Product Change Notification

TRIMPOT® TRIMMING POTENTIOMETERS

Bourns® Trimpot® Product Line Announces Product Change for Model 3313

Current Model

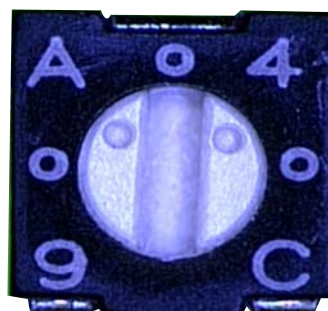
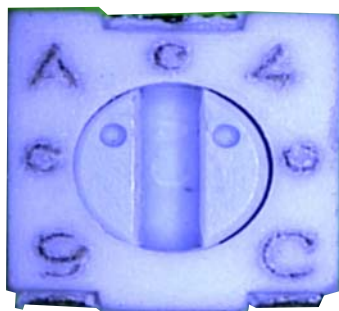
Bourns® Trimpot® Product Line has updated the housing material for the Bourns® Model 3313. This improved housing material is now halogen free**. There is no change to form (except color), fit or function. The halogen free material will come in a black color. A benefit of this color change is an enhanced contrast in marking.

We will begin phasing in this material on April 1, 2012.

- The effective date code will read 2E.
- The expected last date of manufacture of the current product is April 15, 2012.
